Thank you for your comments on the proposed Life Extension to the Coniston Generating Station (GS) Project. Please find below responses to your comments.

Comment #1 - Greenhouse Gas Emissions

AVERAGE, MAXIMUM, AND MINIMUM MONTHLY FLOWS AT CONISTON GS (KGS Group 2018)

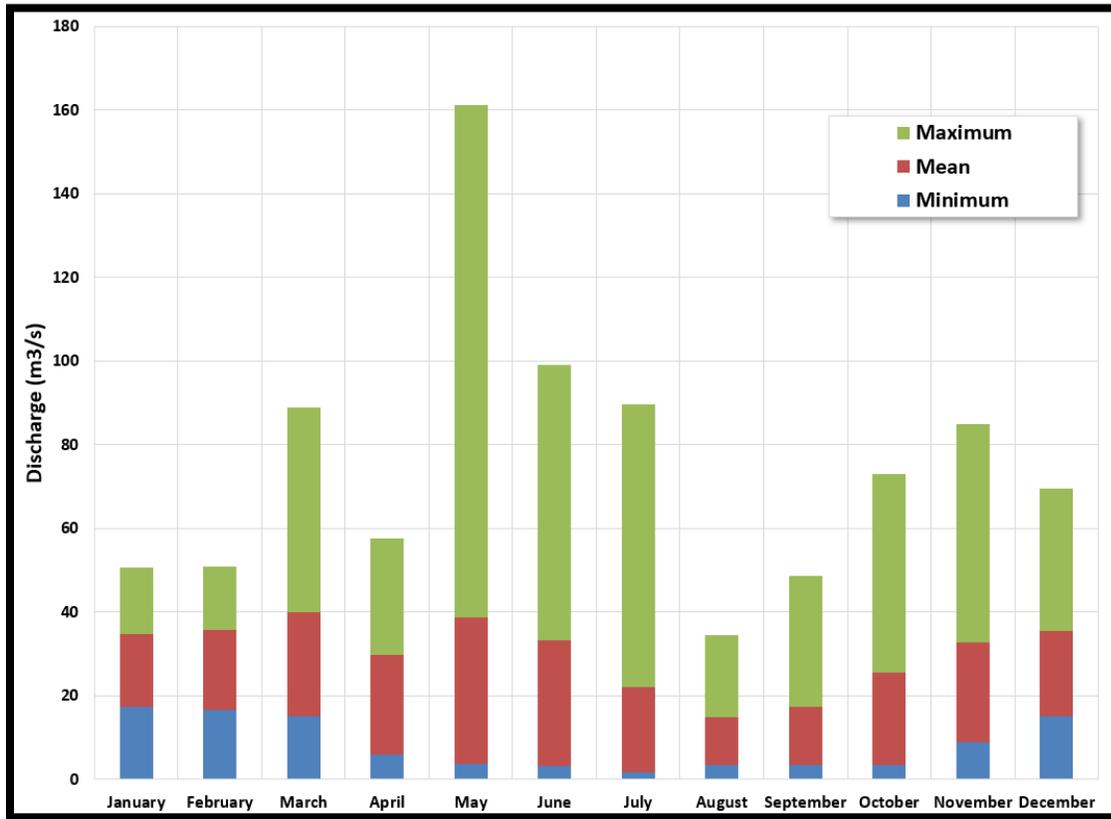
Comment #3 – Zone of Impact

The presentation shows a very small zone of impact, that includes very little of the upstream, except in the immediate vicinity of the dam, and a very short distance downstream of the dam. This facility will cycle its operations, which can have major impacts on both the upstream and downstream. The

upstream and downstream area that would be impacted by the operating strategy was always referred to as the Zone of Influence, so it is interesting that now it is a much smaller area that is referred to as the Zone of Impact. Please provide the following information: a. You only explain that cycling operations will result in fluctuations of downstream flows, when in fact it will impact on upstream and downstream water levels and flow volume. Why are you not taking into account the impact on the upstream reservoir? b. What is the distance between the dam and the upstream zone of impact? c. What is the distance between the dam and the downstream zone of impact? d. Why does the zone of impact not include Coniston Creek, when the presentation mentions that MECP requires the shutdown of all turbines to dilute metal concentrations that flow into the Wanapitei River from Coniston Creek? e. Why does the zone of impact not extend much further upstream when the cycling will create fluctuations in water levels and flows which will likely result in erosion, turbidity, increased water temperatures and greenhouse gas emissions?

Response #3 – Zone of Impact

As you point out, OPG has identified a relatively small zone of impact. That is because the environmental effects of the project will occur in close proximity to the GS. Environmental assessment regimes across the globe are premised on assessing the impact of a proposed project against present environmental conditions. They are not premised on assessing the impact of a project according to some pre-development or historical condition. This project's zone of impact was assessed in the same manner.

As mentioned above, OPG will be operating within the current operating regime of the WRWMP. Until recently the plant's capacity was 4.75 MW (max flow 44 m³/s). The new 6 MW (max flow 43.5 m³/s proposed) capacity stated is the result of new and more efficient generating units operating at near the same historical maximum flow of 44 m³/s. Recently, with only one operating unit (1 of 3), the capacity of the GS has been limited to well below 4.75MW and there has been limited "cycling" of units during low flow periods in order to pass the minimum daily average flow (3 m³/s). The existing WRWMP rules have and will continue to be followed. The operating rules were set up recognizing the ecological conditions of the River and were the culmination of a multi-year planning process involving numerous stakeholders and government agencies examining various conditions and issues on the River.

The only change in water management operations will be that with new functional units the station will be able to pass the available flow to generate power rather than it be passed through the spillway. As the plant was and will remain a run-of-the-river GS and only pass what flow is available from natural inflow there is very little storage capacity in the reservoir, and it will continue to be operated according to the same WRWMP operating rules. Flows through units will vary based on unit capacities and units will be cycled on or off to suit the natural available inflows with excess flow being spilled (beyond plant capacity) through the spillway. OPG has limited storage and a limited operating range (0.55m) in accordance with the WRWMP that peaking style operations are not possible. In short, the new plant is meant to be highly adaptable to various flow conditions.

No changes in operations will occur with the proposed new GS and would not have any identifiable ecological impacts on the River as total flow passed at the site will continue to match inflows on the river system. The Zone of Impact for the upstream side is just slightly upriver of the proposed dam (less than 100 meters) and was identified to account for possible cofferdams that may be required on the upstream side of the dam. The zone of impact does not extend further upstream because the GS will still

be operating within the operating rules already established within the WRWMP. The Zone of Impact for the downstream side potentially extends approximately 200 meters downstream of the powerhouse in order to include an area for the possibility of in-water work associated with fish habitat; cofferdams in close proximity to the powerhouse; and on the terrestrial side for possible vegetation clearing. The Zone of Impact does not include Coniston Creek because the proposed project won't impact Coniston Creek nor the requirement to maintain flow in the River. For context, there is a minimum daily average flow of $3.0 \text{ m}^3/\text{s}$, maintained at the request of MECP to dilute metal concentrations that flow into the Wanapitei River from Coniston Creek. These high metal concentrations have nothing to do with OPG operations and OPG provides this flow to assist with this existing environmental problem. OPG would continue to provide the minimum daily average flow in the river regardless of whether the life extension of the Coniston GS occurs or not. Lastly you indicate: "Why does the zone of impact not extend much further upstream when the cycling will create fluctuations in water levels and flows which will likely result in erosion, turbidity, increased water temperatures and greenhouse gas emissions?" The proposed re-development of the GS will not result in such effects because it will not change the overall flows and levels in the River from the existing conditions. To re-iterate, the overall compliance levels and flows will remain the same and therefore the effects will not change. It is important to remember that a River does have variable hydrological conditions. Inflows vary hourly, daily, monthly seasonally, annually and year-to-year. OPG maintains historical records, constantly assesses levels and flows and assesses the impacts of future climate changes scenarios on the hydrology for the Rivers it has facilities on. OPG uses that information to continue to manage the flows and levels on these rivers according to the compliance regimes set out in water management plans. The natural variations in the hydrology of the Wanapitei River are far greater than any slight changes that would occur with a new powerhouse (please see the figure below for data on the monthly historical flow record of the station) and with the new facility operating as a run-of-the-river facility. It is those natural/wider fluctuations that are more likely to produce the affects you suggest such as turbidity and erosion. But the compliance rules developed in the WRWMP were developed recognizing all of the historic and natural conditions.
